Seattle Multimodal Terminal at Colman Dock Project

Finding of No Significant Impact

November 2015

Seattle Multimodal Terminal at Colman Dock (Seattle Ferry Terminal) Project

A SCHEME FOR THE IMPROVEMENT OF SEATTLE'S COLMAN DOCK
 THE BASIC PREMISE FOR THIS SCHEME IS TO: "EXPAND THE CITY STREET GRID"
 SO THAT DOCK STREETS ARE ALIGNED.
 DESIGNED: GIGUARDI ARCHITECTS BAINBRIDGE ISLAND. || EXIST. DOCK --- 567± CARS
 || PROPOSED DOCKS --- 1,390± CARS

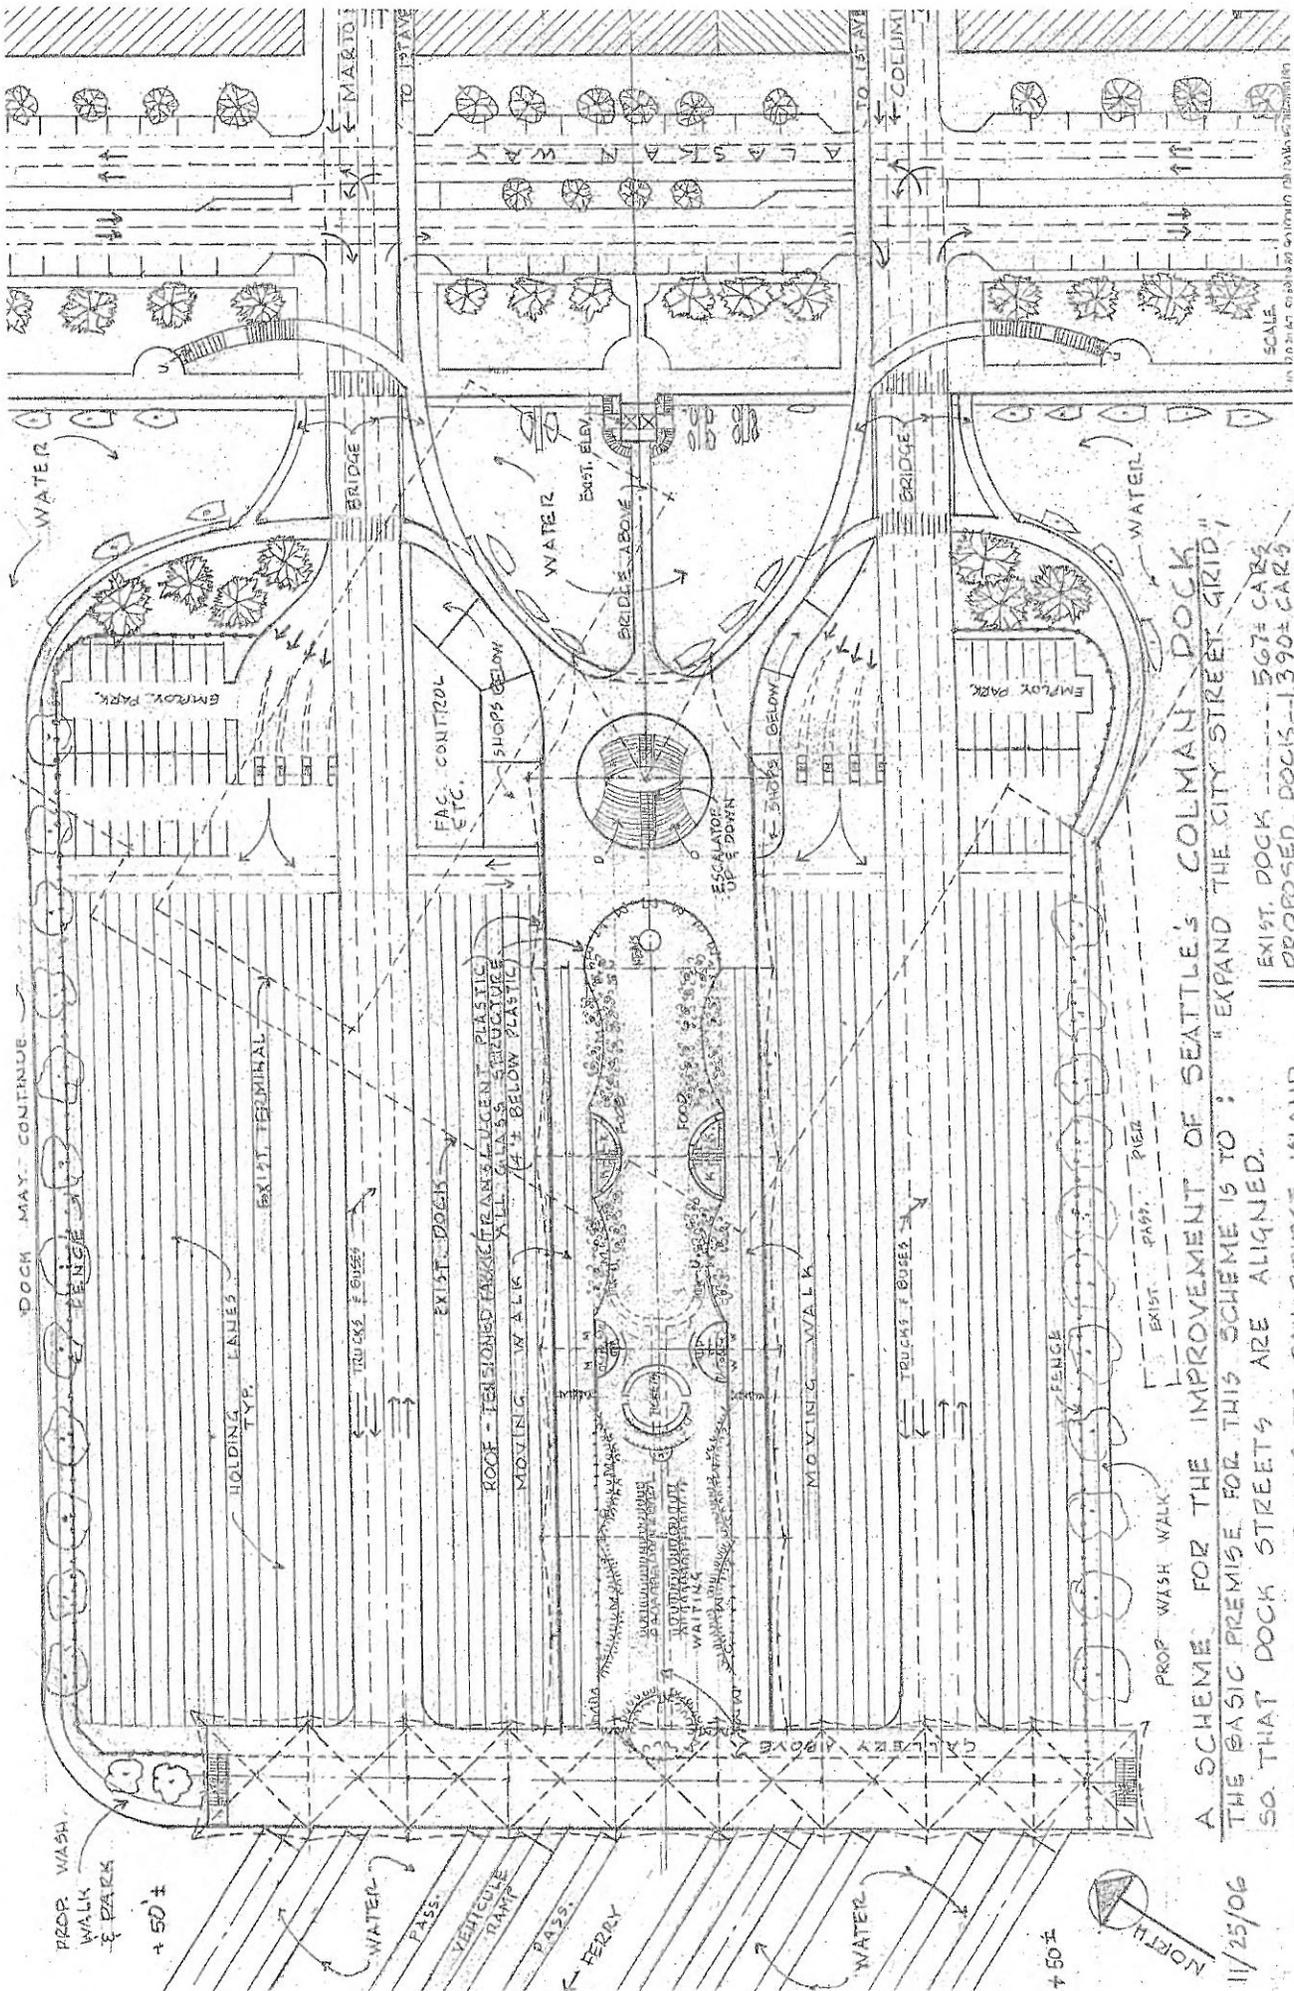
No.	Date Received	Comment Type	Commenter Name	Comment	Response
53.	4/28/2014	Written submittal at Public Hearing (copy of comment and design drawings follow this page)	Richard LaBotz	<p>Many of Colman Dock's existing design flaws are not addressed with the proposed design. Circulation on Colman Dock and Alaskan Way causes lines of cars and trucks to wait on Alaskan Way. I have enclosed designs prepared in 2006 showing revised entries aligned with both Columbia Street and Marion Street. This would allow two entries to the dock at peak times and improve the operation of the Alaskan Way intersection. The intent is to have the intersections merge into the "fabric" of the City.</p>	<p>As noted in the comment letter, the design suggestions illustrated in the submitted drawings were prepared in 2006, when a substantially different project was being considered by WSDOT. Since that time, the project has been revised to meet legislative direction (EA, p. 2-6), and the approved project budget has been developed to match the revised project's scope and scale (FONSI, p. 2). Suggestions to increase Colman Dock vehicle storage from the existing 596 spaces to 1,390 spaces, to install several bridges from Colman Dock to First Avenue along both Marion and Columbia Streets, and to reconfigure the dock as recommended in the comment letter would be difficult to accommodate under the current project's budget, and would potentially require additional overwater coverage.</p> <p>Allowing two driveway entries at peak times to allow quicker entry to the site would not appreciably address existing queues along Alaskan Way, since the dock space is already fully occupied at peak hours. While the project is not intended or designed to solve all existing problems on Alaskan Way and on the dock, the Seattle Ferry Terminal Project will preserve existing capacity on Colman Dock while addressing seismic deficiencies, deteriorated trestle conditions, ADA compliance, and pedestrian/bicycle/vehicle conflicts.</p>
